GULF STATES UTILITIES COMPANY

March 1, 1985
RBG- 20,270
File No. G9.5, G9.8.6.2

River Bend Station - Unit 1
Docket No. 50-458

ATTACHMENT 1

FIGURE 6A.5-1

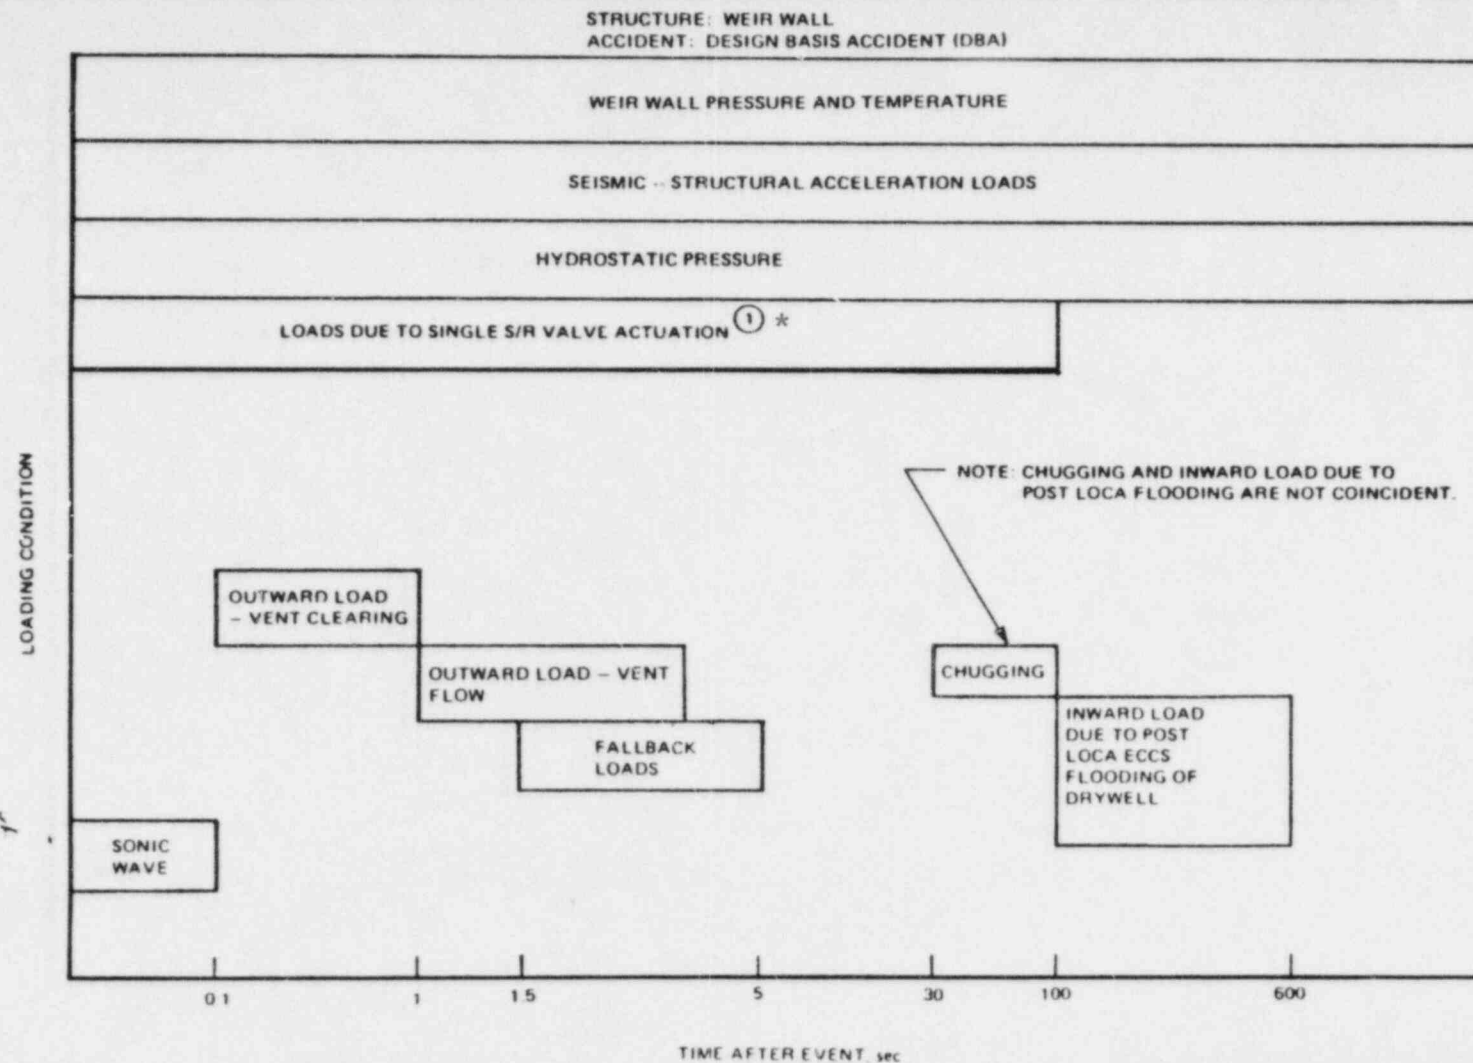
- (i) Figure 6A.5-1 (corresponding to GESSAR Figure 42) does not contain the Figure 42 comment regarding the SRV & drywell air carryover load combination. Please explain.
- (ii) Same question for Figure 6A.6-1 (corresponding to GESSAR Figure 48).

- (i) Figure 6A.5-1 has been revised to add the asterisked note (*) that appears on the corresponding GESSAR Figure 3B-42.
- (ii) This question was withdrawn by the NRC (Mel Fields) in a telephone conference Monday, January 28, 1985.

* Add S/R dynamic load to static load due to drywell air purged to containment

FIGURE 6A.10-5

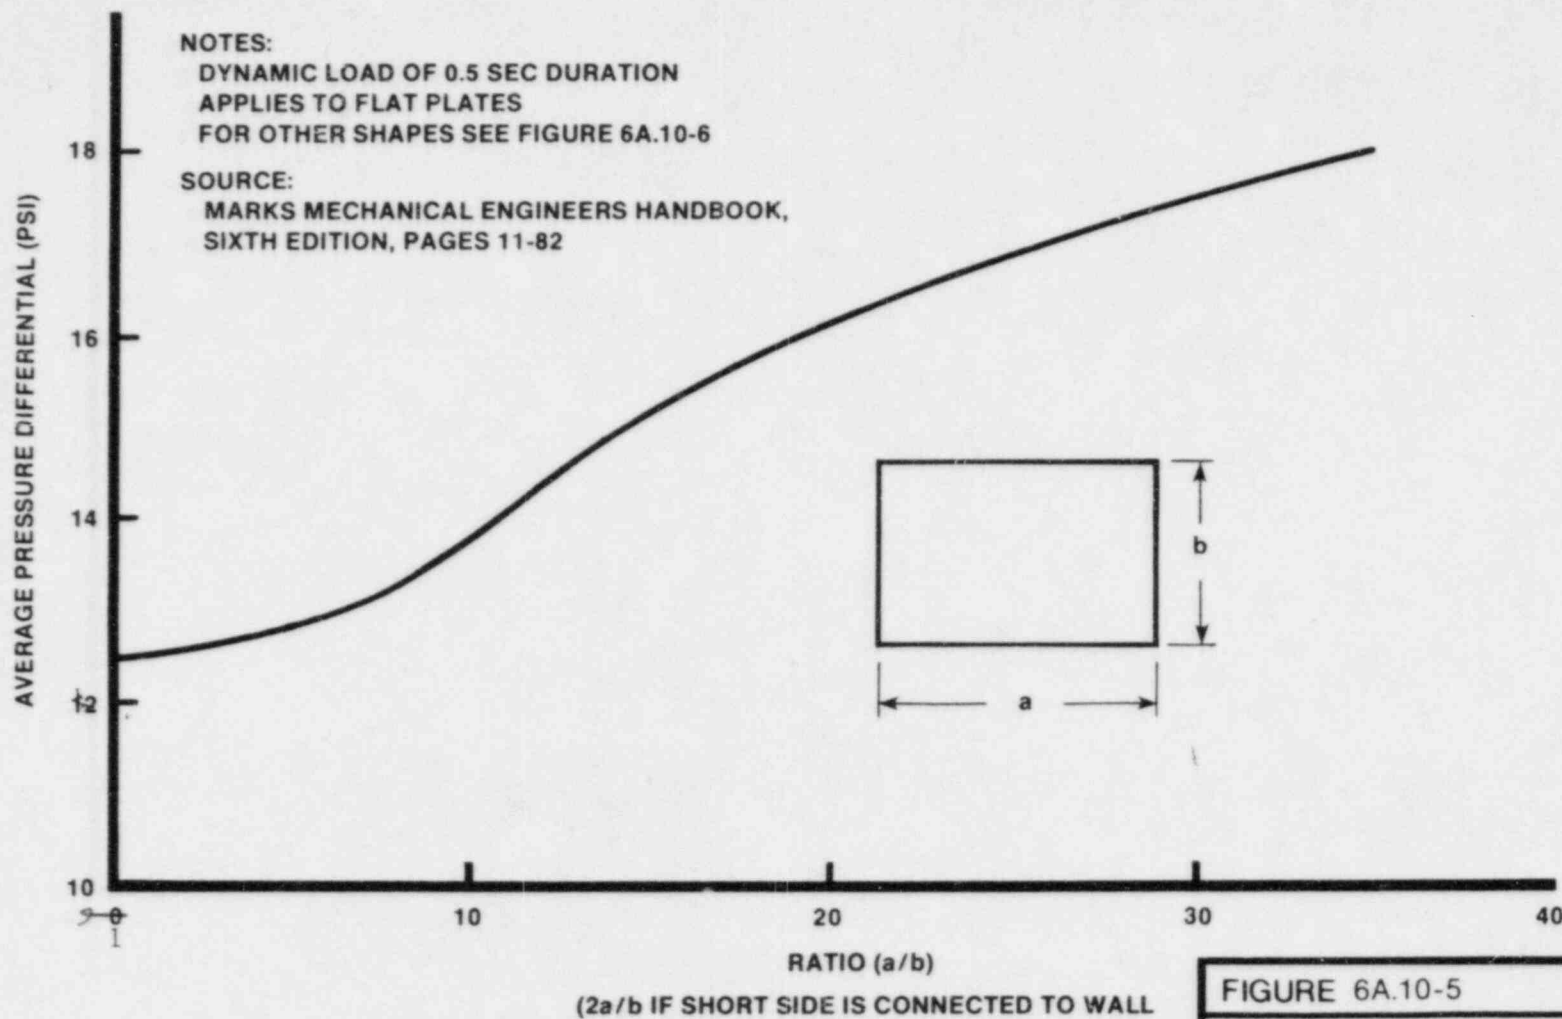
The abscissa of Figure 6A.10-5 must start at 1.0 and not at 0 as drawn. Note that the lowest pressure drag is observed on a square plate, $a/b = 1.0$ and it increases as this ratio becomes either larger or smaller than 1. Thus, in the limit of $a/b = 0$, one has an infinite strip with a drag coefficient of 2.0 and a pressure differential of 21.6 psi (for $V = 40$ ft/sec). The figure does not show this.

See revised Figure 6A.10-5 contained in Enclosure 1. The zero (0) is changed to one (1).

Fig. 6A.10-7

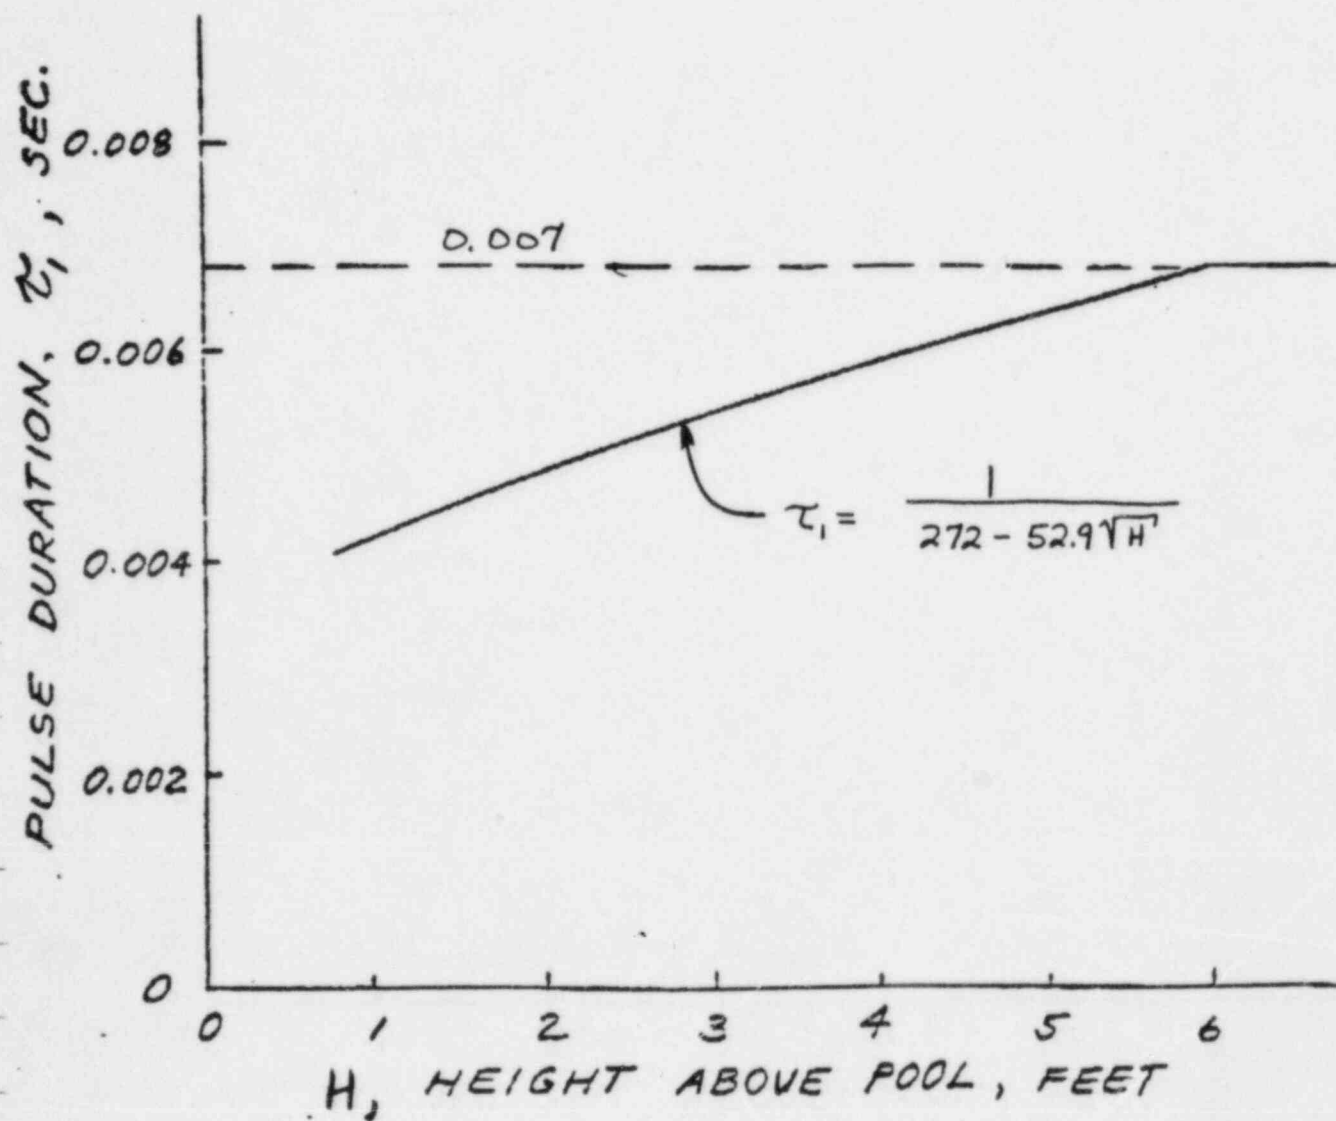
The pressure amplitude for short ($x < 4$ ft) circumferential structures is not determined correctly. The method outlined can lead to an incorrect impulse of impact. Please refer to "Suggested Acceptance Criteria for Impact Loads on Short Mark III Structures Close to the Pool" by G. Maise, February 15, 1984.

For radial and circumferential structures within 6 feet of the pool surface, the pressure amplitudes are first adjusted based on Equation 3-7 of NUREG-0978. The pulse durations are reduced based on procedures described in G. Maise's "Suggested Acceptance Criteria for Impact Loads on Short Mark III Structures Close to the Pool", February 15, 1984. The final impact pressure is then found by equating the impulse for the 0.007 second duration with that for the reduced pulse duration:

- For structures within 6 feet of the pool surface, the pulse duration τ_1 is given in Figure 6A.10-7.
- For structures less than 4 feet in length, the pulse duration τ_2 is given in Figure 6A.10-8.
- For structures both less than 4 feet in length and within 6 feet of the pool surface, the pulse duration is given by:

FIGURE 6A.11-1

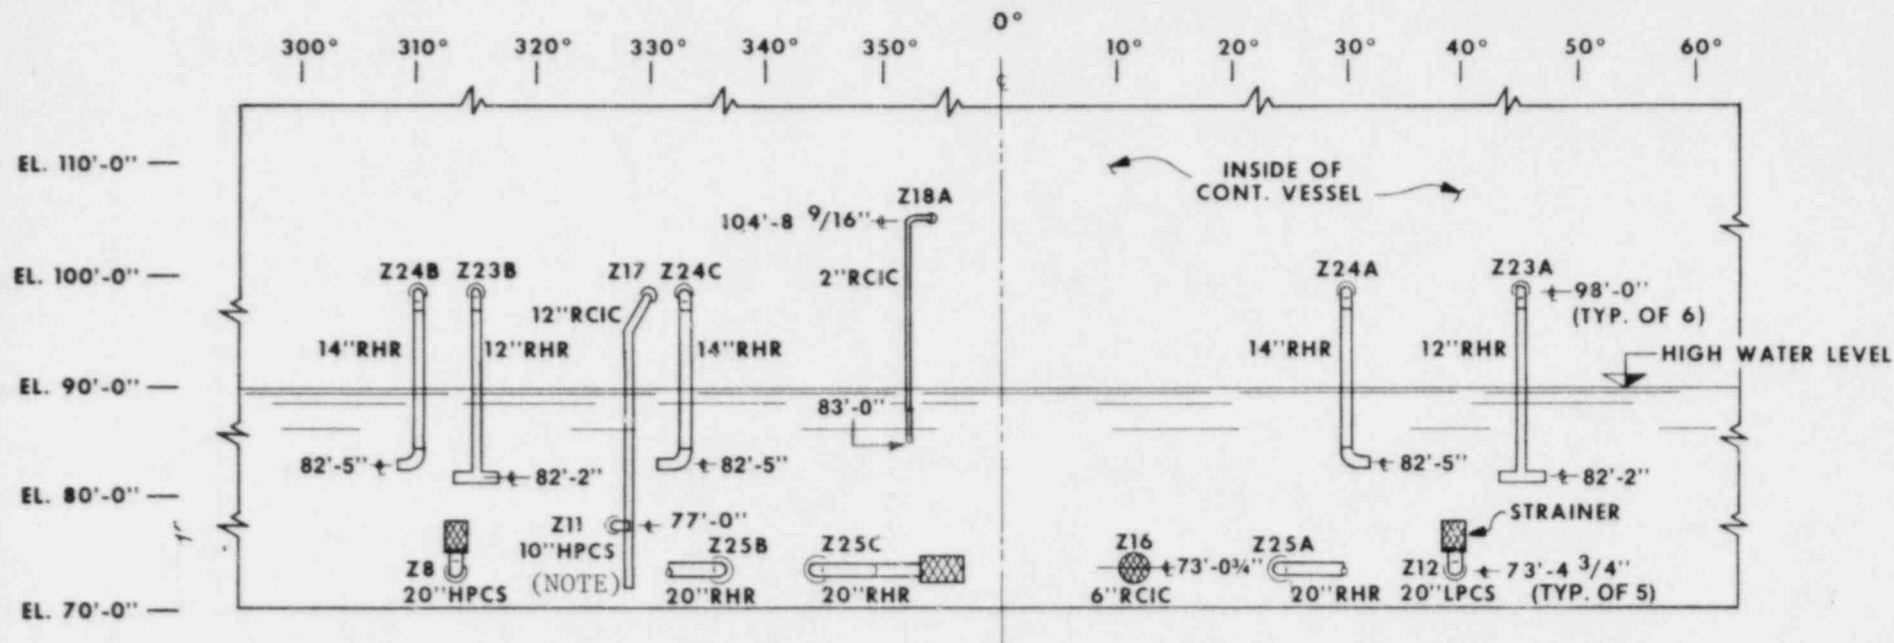
The note on Figure 6A.11-1 indicating that the pulse duration for impact cannot be less than 50 msec, is misleading. This applies only to radial structures that span the entire pool annulus. The statement in the text on page 6A.12-1 is correct, however, the use of Figure 6A.11-1, by itself, can lead to errors.

See revised Figure 6A.11-1 contained in Enclosure 1. The note has been clarified.

IMPACT
 NOTE: DURATION CHOSEN TO GIVE THE MAXIMUM DYNAMIC LOAD FACTOR,
 BUT NOT LESS THAN 50 MSEC FOR EXPANSIVE STRUCTURES
